# Technical Note: Response to Oxfordshire County Council

Project: Great Wolf Lodge, Chesterton

19/02/2020

Drawing 1803047-03

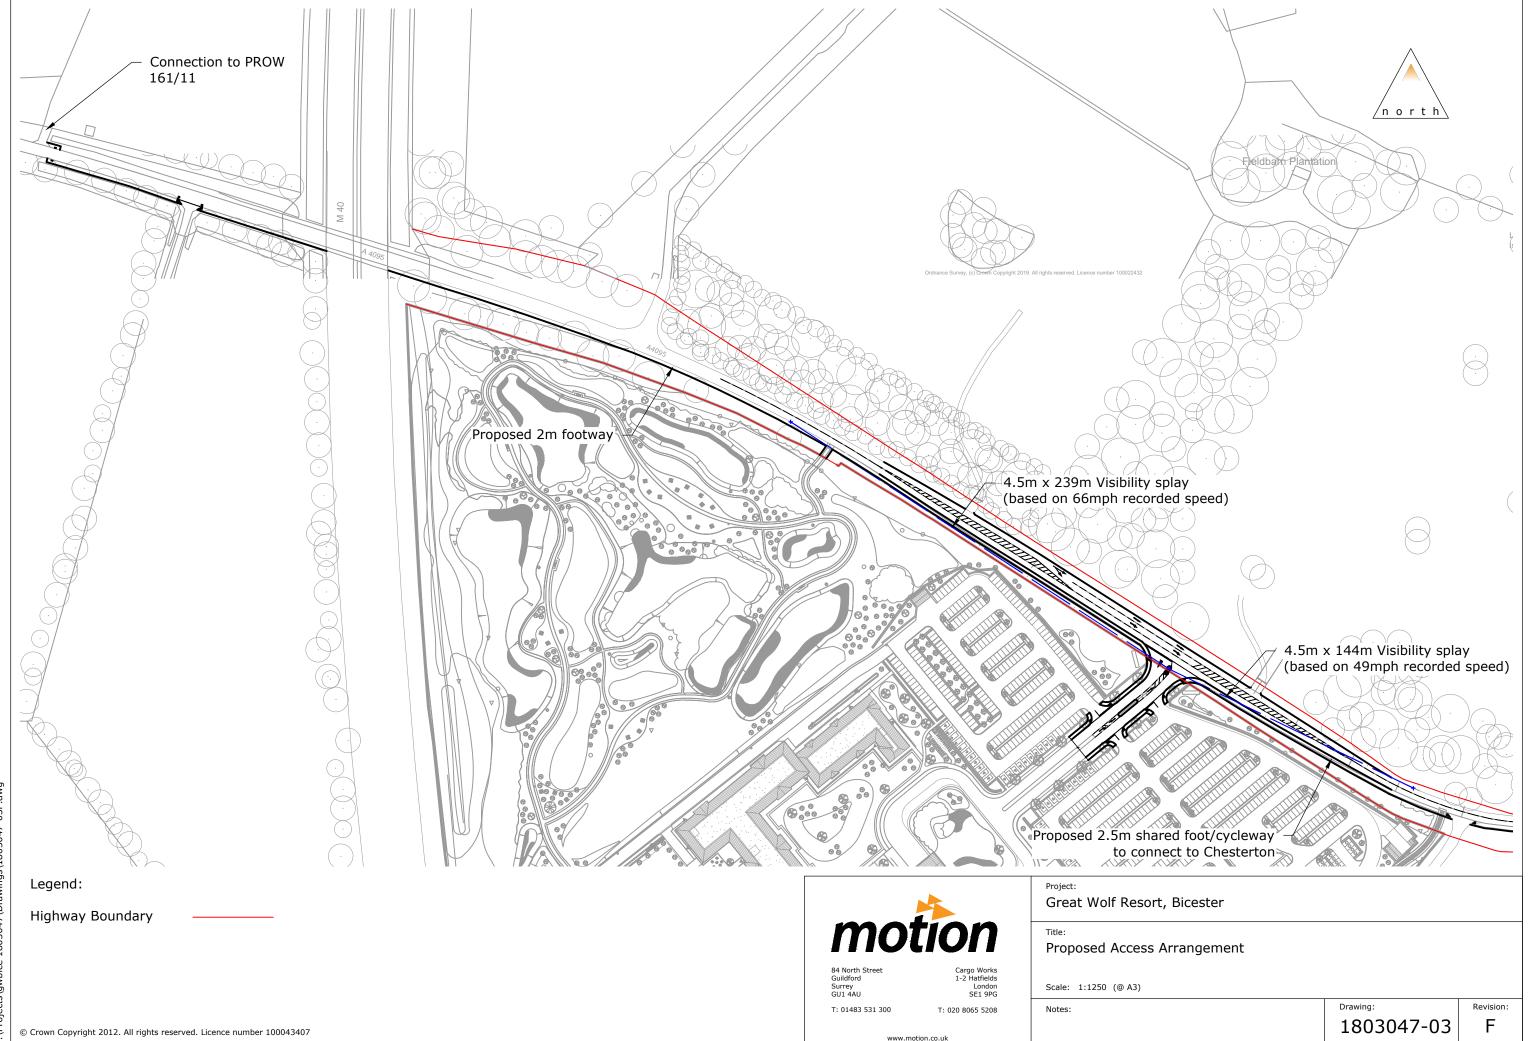
- 2.12 Following discussions with OCC it is now proposed that an additional stretch of footway of circa 370 metres in length is provided along the A4095 west of the site access junction, either side of the motorway overbridge, to connect with PRoW 161/11 to the west. This provides a betterment to the existing connection between PRoW 161/06 and PRoW 161/11, providing pedestrians with a footway where they are currently required to walk within the grass verge to connect between PRoW 161/06 and PRoW 161/11. The proposed extended footway is shown on Drawing 1803047-03, attached at Appendix A.

Drawing 1803047-15

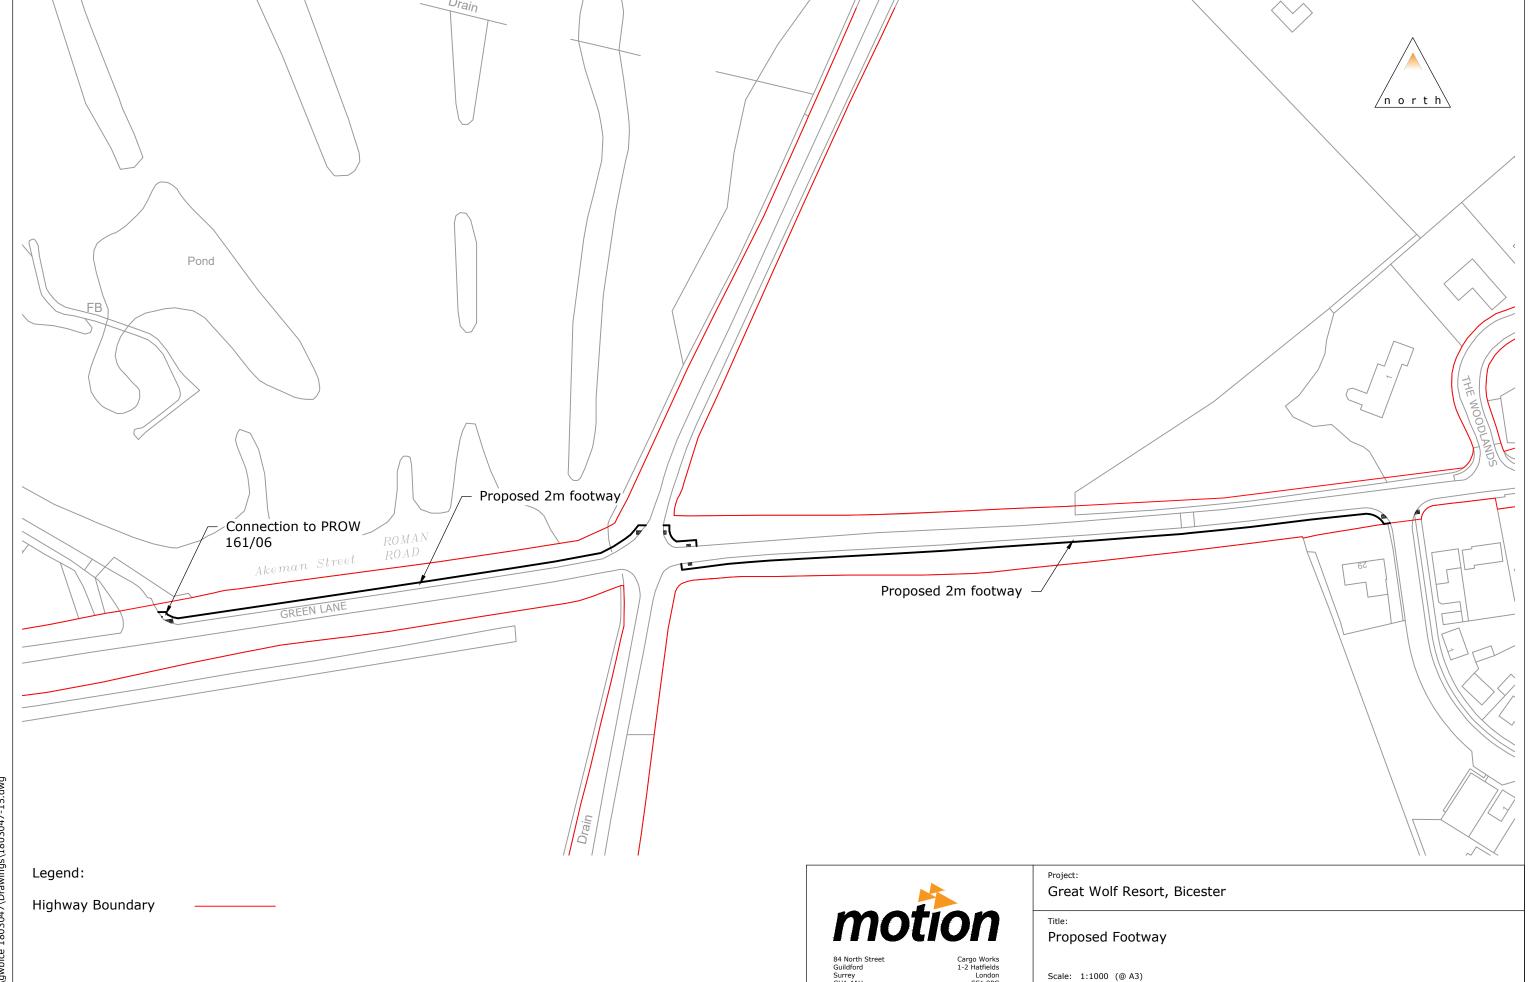
- 2.13 In addition, it is proposed to provide a new section of footway of circa 400 metres in length on Green Lane, either side of its junction with The Hale, from the southern end of PRoW 161/06 east to connect with the existing footway within Chesterton. The proposal provides a betterment over existing facilities for pedestrians providing a footway connection from the southern end of PRoW 161/06 to Chesterton, where pedestrians are currently required to walk within the grass verge. The proposed footway is shown on Drawing 1803047-15, attached at Appendix B.
